# NORTHEAST UTILITIES

May 22, 1984

Millstone Nuclear Power Station, Unit No. 3  
Summary/Submittal of Responses to RSB  
Draft SER Open Items

### Summary of the Status of RSB Items from the NRC Meeting May 9, 1984

FIGURE 6.3-6  
REFUELING WATER STORAGE  
TANK WATER LEVELS  
MILLSTONE NUCLEAR POWER STATION  
UNIT 3  
FINAL SAFETY ANALYSIS REPORT

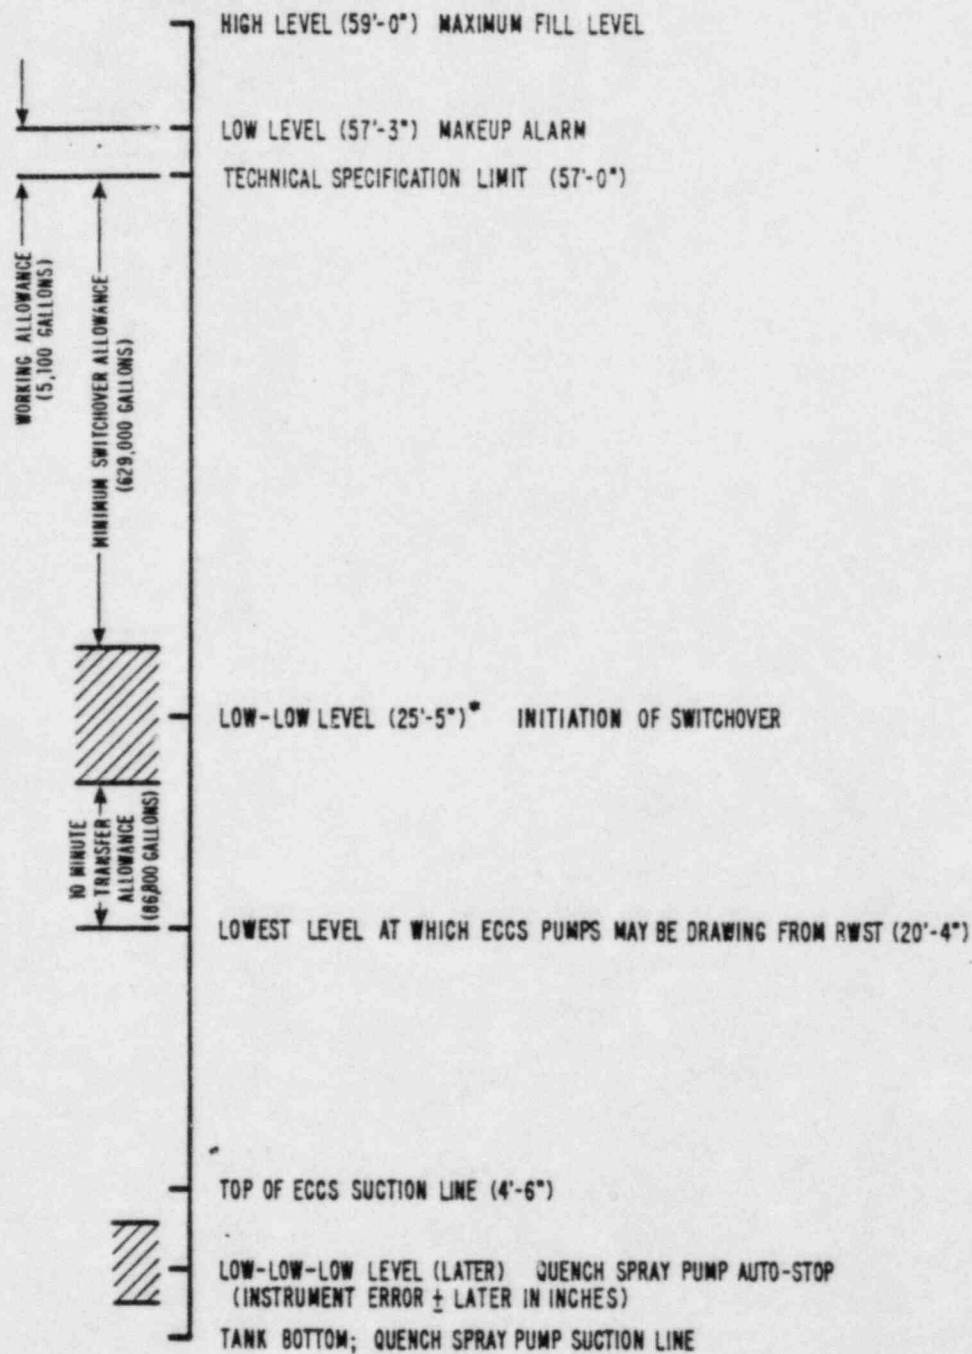
Recently, a similar plant has indicated that a design error existed in the sizing of their RWST. This error was discovered during a design review of the net positive suction head requirements for the containment spray and residual heat removal pumps. The review showed that there did not appear to be sufficient water in the RWST to complete the transfer of pump suction from the tank to the containment sump before the tank was drained and ECCS pump damage occurred.

In light of the above information, discuss the adequacy of your refueling water storage tank design. Provide a discussion of the necessary water volumes to accommodate each of the considerations indicated above. Justify your choice of volumes necessary to account for each consideration of tank suction lines, and level sensors.

Refer to revised FSAR Section 6.3.2.8 for a discussion of RWST water volumes for the necessary allowances.

Vortex formation at the inlet of the ECCS pumps suction line in the RWST will not occur, as the minimum RWST water level at termination of switchover is approximately 16 feet above the top of the ECCS suction line. Refer to revised FSAR Section 6.2.2.2 for a discussion of vortexing at the quench spray pump suction nozzles.

The minimum time that would elapse from initiation of a LOCA to initiation of switchover to the recirculation mode is then 629,000 gallons divided by 17,410 gpm, or approximately 36 minutes. This is the minimum time available for the operator to prepare for switchover. Refer to Figure 6.3-6 for a presentation of RWST water levels and volumes.
